ASSESSMENT REPORT			
Unique Document ID and Revision No:	ONR-OFD-AR-18-003 Revision 0	TRIM Ref:	2018/144215
Project:	Hinkley Point B Reactor 4 2018 Periodic Shutdown		
Site:	Hinkley Point B		
Title:	Hinkley Point B Reactor 4 Periodic Shutdown: Structural Integrity Assessment of the Graphite Core Inspection Findings		
Nuclear Site Licence No:	62C		
Licence Condition(s):	LC 30		
ONR Assessment Rating (Mandatory): <i>(Rating should be based on licensee's original safety case submission)</i>	GREEN		
COIN Service Order:	SVC4285368

**Hinkley Point B Reactor 4 Periodic Shutdown 2018 – Graphite Structural Integrity
Assessment**

Assessment Report ONR-OFD-AR-18-003
Revision 0
May 2018

Figure 1: Full axial bore crack observed in Layer 9 of Channel J29.

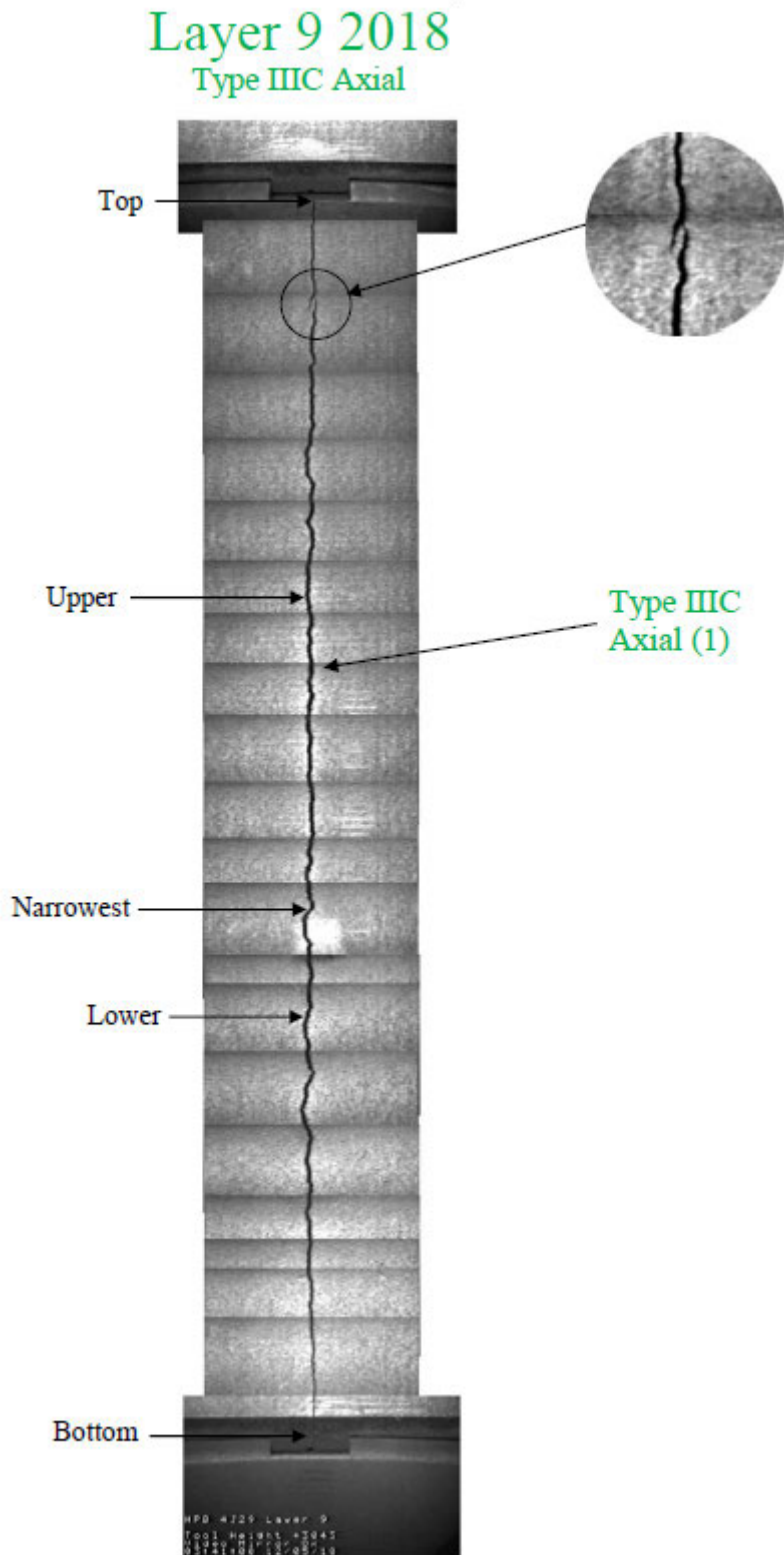
33. When a defect has been identified, the licensee produces an image of the brick containing the defect from the data collected during the inspection. This image is then collated along with other measurements in a 'GAP sheet' and sentenced by graphite inspection SQEPs during the subsequent GAP meeting. During the inspections, only one new full height axial bore crack was found in Channel J29 (Ref. 14). This channel had not been inspected previously. The defect is shown in Figure 1.

34. This crack presents some features common to KRCs, close to a keyway, relative straightness. However, its cardioid plot shows the 'lipping-in' which is characteristics of bore cracks and is associated with the tensile stresses increasing at the bore in early life of the graphite; see Figure 2.

Figure 2: Cardioid plot derived from the bore measurements in Channel J29.

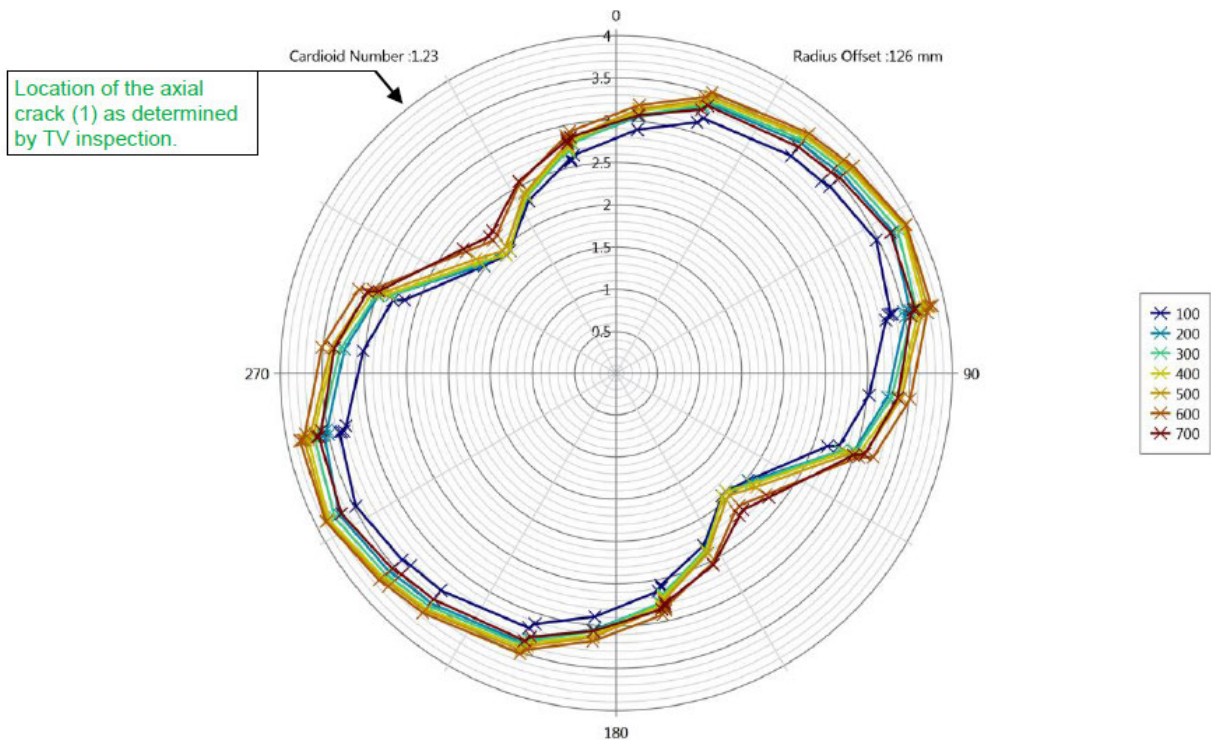
- 35. In Figure 2, the '100' location corresponds to the top brick in the channel and '700' corresponds to the lowest brick. It follows from these measurements that the crack observed is a bore crack and was sentenced as such by the GAP.

- 36. Since bore cracking is considered to be an early-life phenomenon, the total number of such cracks in the reactor is unlikely to change and newly observed bore cracks only highlight the fact that the channels had not been previously inspected. The estimates for the number of single axially cracked bricks are below the safety case allowance. I expect that this level of bore cracking will not significantly progress as the core ages. NGL considers circumferential cracks to be relatively benign for the structural integrity of the core because of their relatively low instance. This judgement was considered to be reasonable in ONR's assessment of NP/SC 7662 (Ref. 17).

Figure 3: KRC in Channel E25, layer 4.

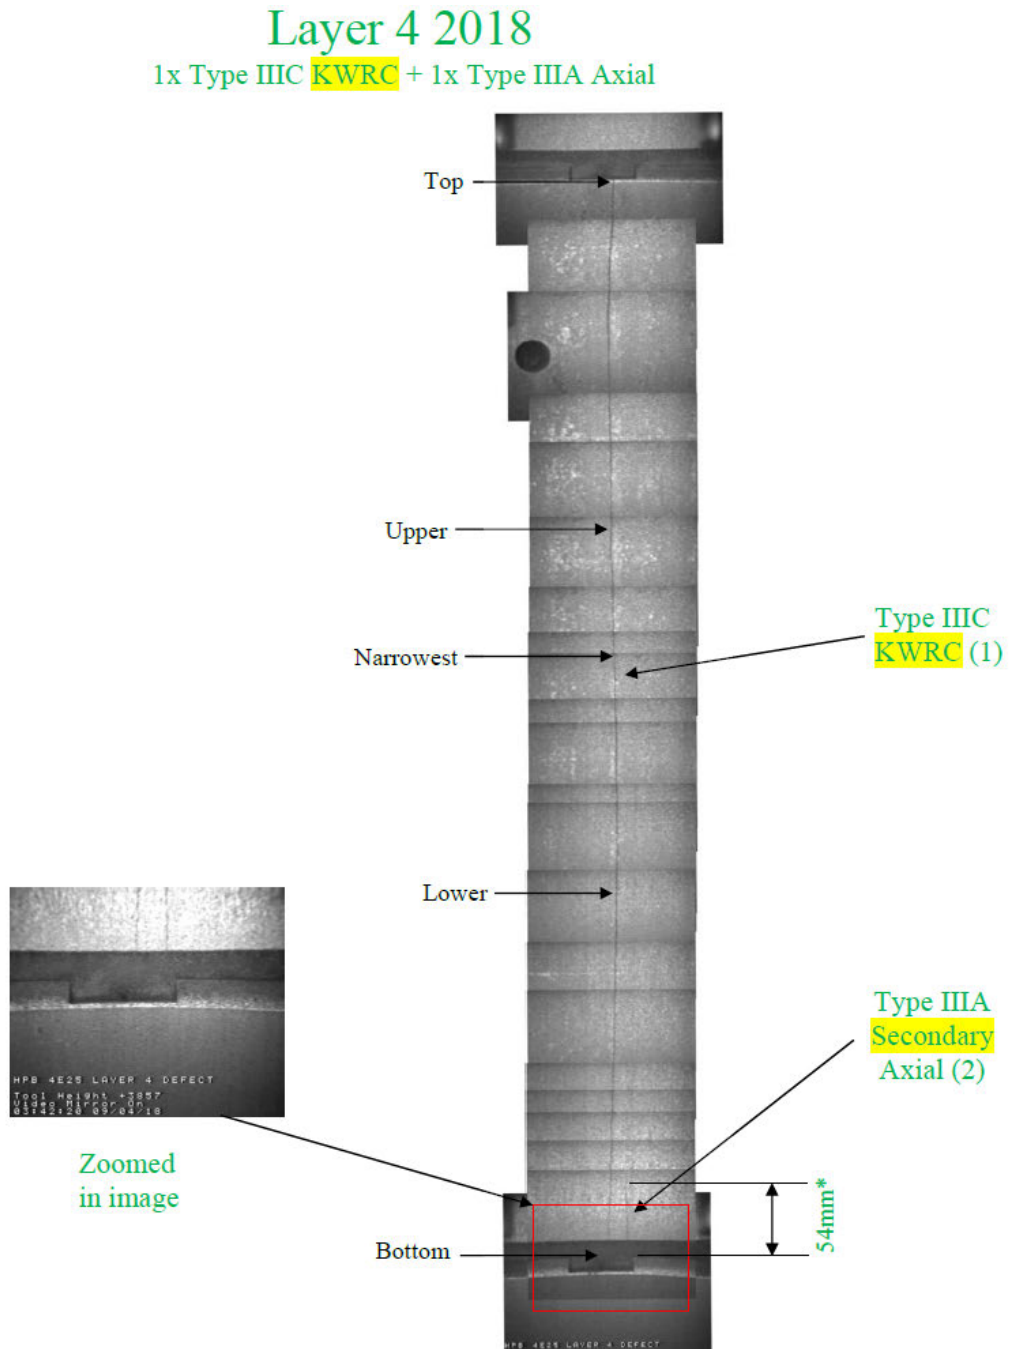
40. This figure also shows evidence of secondary damage from the primary keyway root crack at the corner of the end face. This channel had been inspected in 2002, 2005, 2011 and 2015 and was targeted due to previous low 'lambdas'.

Figure 4: Cardioid plot derived from the bore measurements in Channel E25.

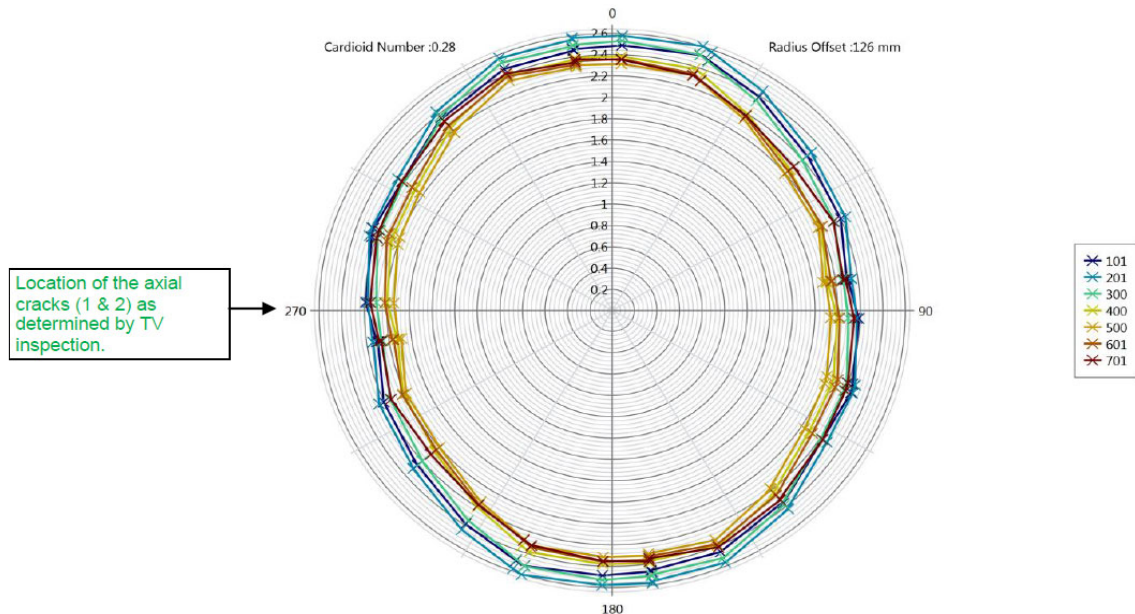
41. Figure 4 shows the cardioid plot for channel E25 which confirms the absence of lipping-in and the sentencing as a KRC. From a structural integrity point of view, KRCs are more significant than bore-initiated cracks since NGL expects their number and the crack opening to increase over time. NGL has developed some models to predict the number of cracks expected during the inspections and make an estimate on the total number of cracks in the core. This observation is therefore consistent with NGL's expectations.

Figure 5: Tilt measurement plot for Channel L15 (Ref. 19).

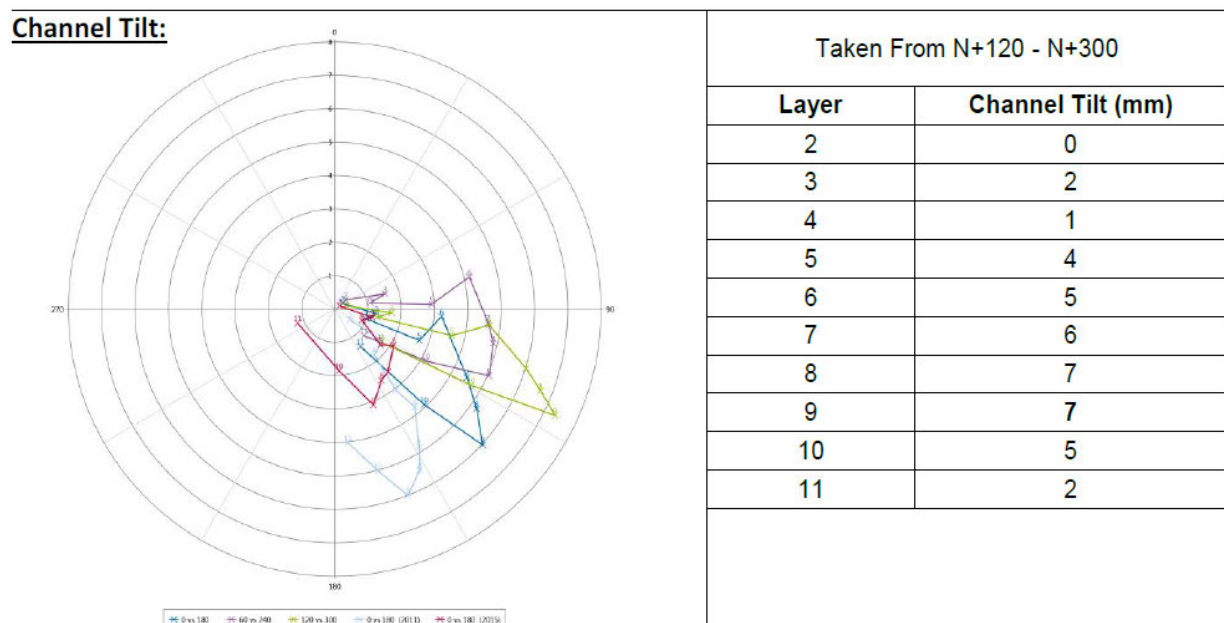
47. During the inspections, NGL notified ONR that one of the transducers, T1-3, was faulty and gave an artificial rotation of the measurements compared to historic data. This is illustrated in Figure 5 below. The licensee also reported that additional twisting the NICIE2 tool could occur during inspections. This twisting was previously accounted for by using an additional factor to represent the difference in average tool twist between the two scan pairs.

48. NGL subsequently repaired the faulty transducer and analysed the data recorded using the faulty transducer. The licensee subsequently reviewed the recent inspection data produced in a short note in Ref. 20. This note identified that the fault occurred in

the 5th channel in the inspection sequence (channel U35) and suggested that these measurements could be corrected using the reading from a single transducers.

49. NGL subsequently proposed a new method in Ref. 21 to derive the tilt measurements from the data retrieved from the valid transducer. The main change concerns a trigonometric formula and is relatively minor. The impact of this change was also reviewed considering 440 historical data, including data from HNB. The changes in the tilt calculations were within 0.1mm of the original calculations, which therefore validates the adequacy of the single transducer method.

Figure 6: Marks in (a) Layer 7 and (b) Layer 2 of Control Rod Channel RS28.

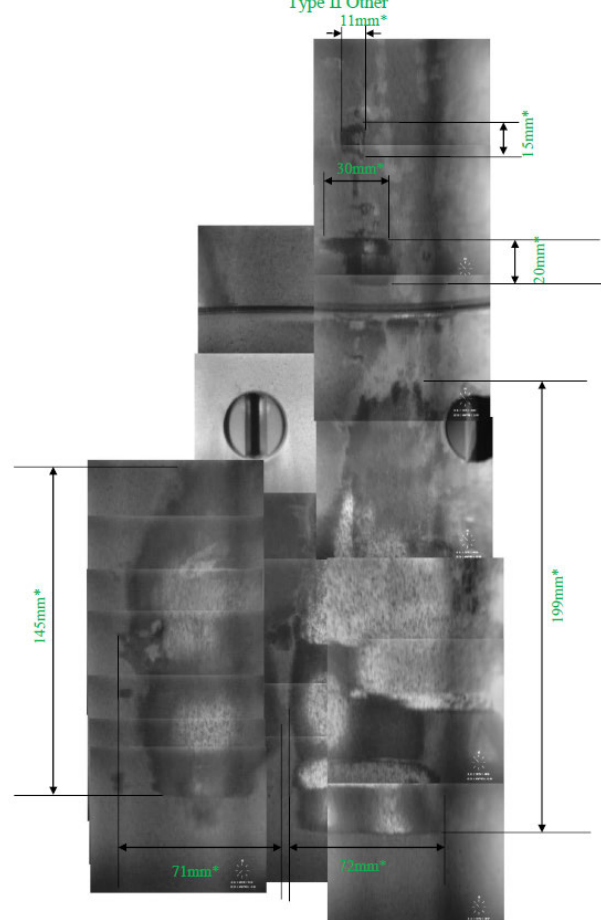
53. These defects were considered by the GAP who classed these defects as 'Type II – Features that could grow into cracks if stresses are sufficient, and cracks of a length that implies existence prior to irradiation non-propagating defect' (Ref. 23).

55. Following ONR's request, the licensee provided some possible explanation for the damage observed in Ref. 24. According to the licensee, the markings observed may have been caused by contact by the control rod during drops, original defects, inspection equipment or the removal of the control rod shock absorbers to allow sub-diagrid viewing. The licensee also mentions that this type of damage had not been observed before, but that similar scuff marks have been observed in fuel channels where the stabilising brushes interact with the channel walls. According to NGL, the

control rod drop times are all within specification and it would appear unlikely the current damage would challenge the integrity of the brick or cause blockage. NGL will consider the observed damage in more detail within the 60 day EC. NGL has also committed to inspect a channel housing a super-articulated control rod of the same manufacturer as the control rod in HPB R4 channel RS28 in the HPB R3 reactor core in 2019 (Ref. 24).

56. I therefore consider that the licensee's commitment to inspect a similar channel in HPB R3 in 2019 is sufficient. However, the licensee could consider performing further inspections of channels housing control rods of a similar design and of a similar manufacturer in the HNB R3 graphite core which may shortly be subject to further inspections. These inspections would help to provide further evidence that the primary shutdown capabilities of the reactor are not affected.

58. Given that damage of the type observed has not previously been observed in other control rod, I recommend that control rod channels housing super-articulated control rods of similar manufacture and from the same manufacturer (IMI 'contract' rods) should be considered for further inspection, both at HPB and HNB.
